THE GLEN AT WIDEFIELD FILING NO. 12
RESIDENTIAL SUBDIVISION CONSTRUCTION DRAWINGS
PREPARED FOR WIDEFIELD INVESTMENT GROUP

EPC STORMWATER REVIEW COMMENTS
IN ORANGE BOXES WITH BLACK TEXT

Kiowa Project No. 19016
May 3rd, 2023

GLEN AT WIDEFIELD NO. 12
Grading & Erosion Control Plan
Filing 12 (Entire Site)
EL PASO, COUNTY, COLORADO

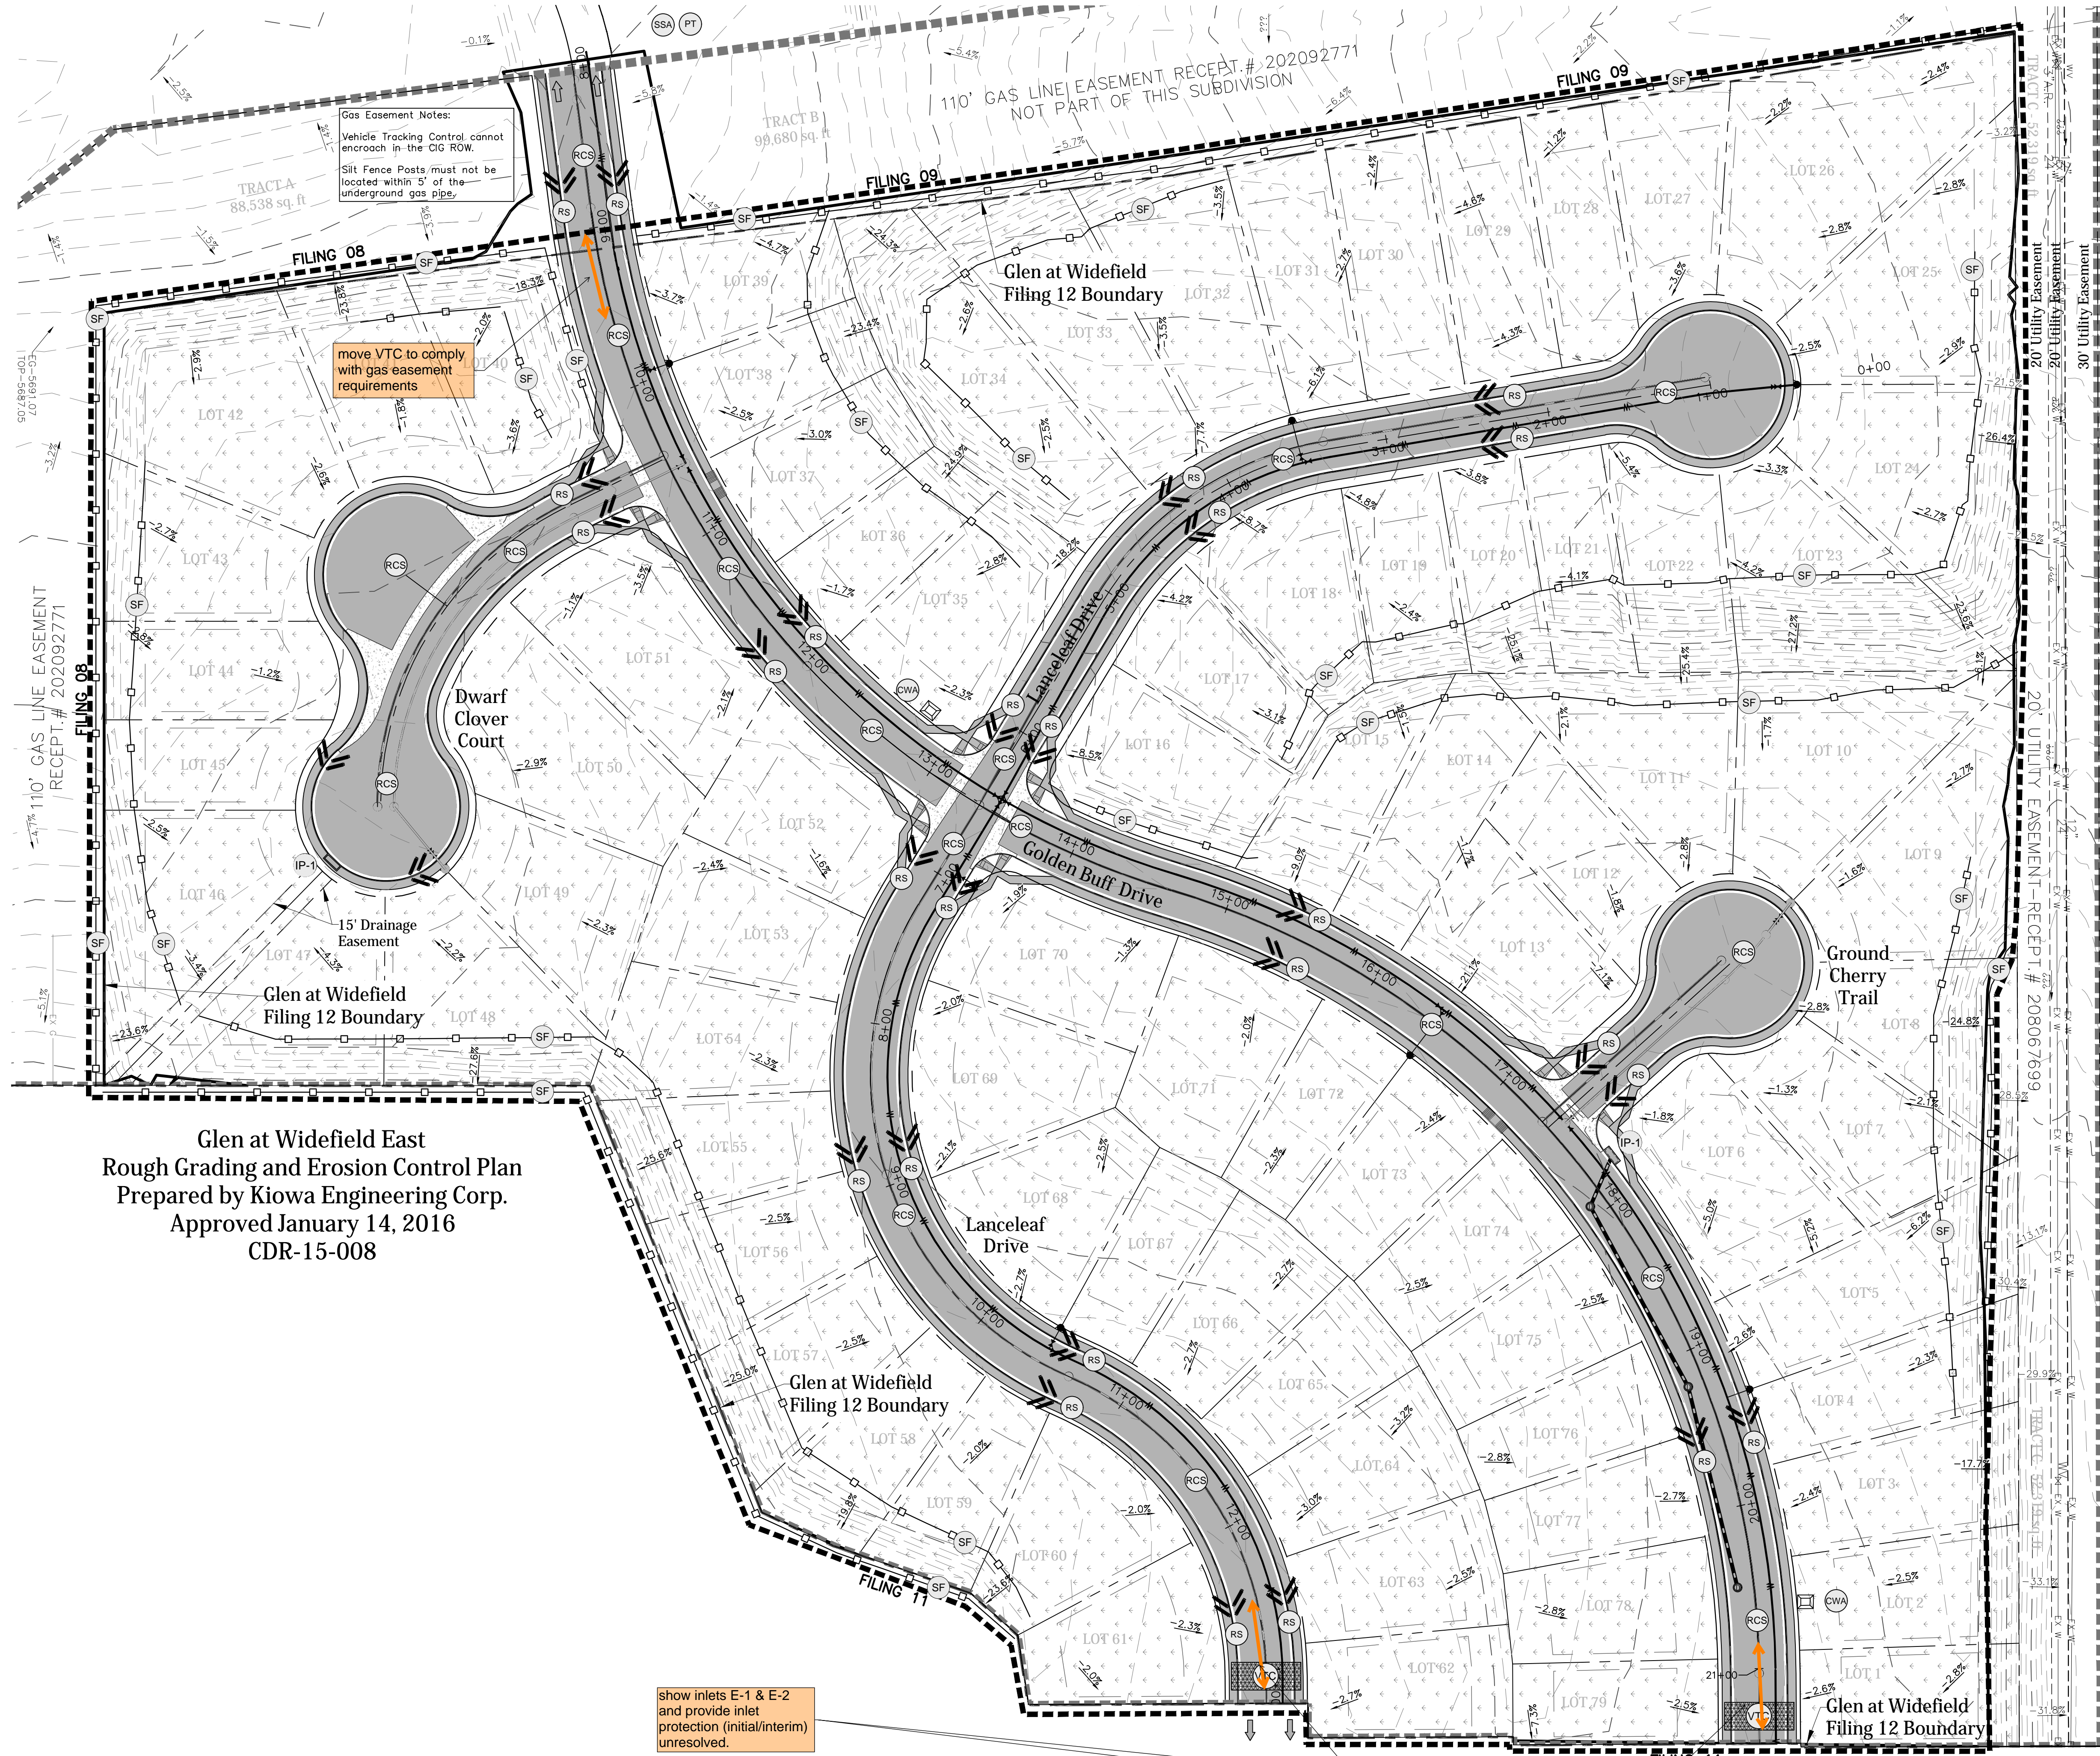
show inlets E-1 & E-2 and provide inlet protection (initial/interim) unresolved.

show inlet B-1 and provide inlet protection (initial/interim) unresolved.

DRIVEWAY DETAIL WITH DETACHED SIDEWALK
EPC STD. SD_2-25
Not To Scale

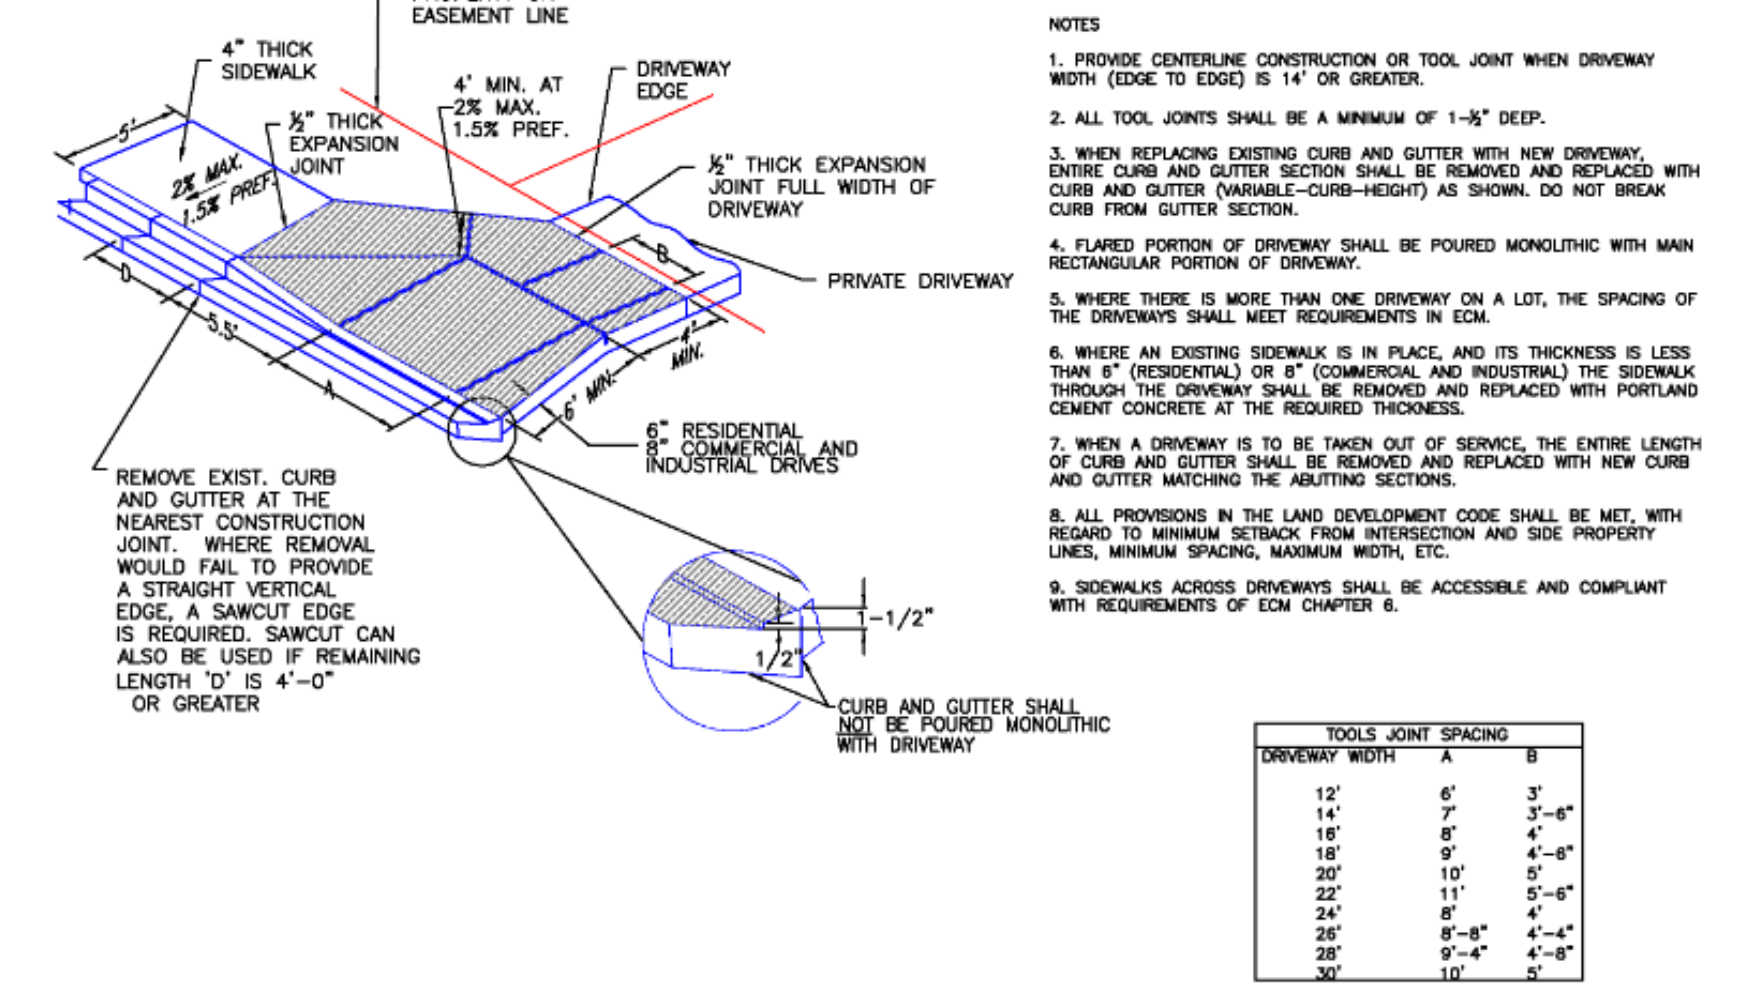
Review 1: Please update to the latest county detail and provide the attached sidewalk detail as all the roadways in the subdivision have attached sidewalks per the road cross section detail
Review 2: Unresolved. Please provide the latest attached sidewalk driveway detail.
<https://mclibrary.blob.core.usgovcloudapi.net/codecenter/15646/367064/AppF-23.png>
Review 3: Unresolved.
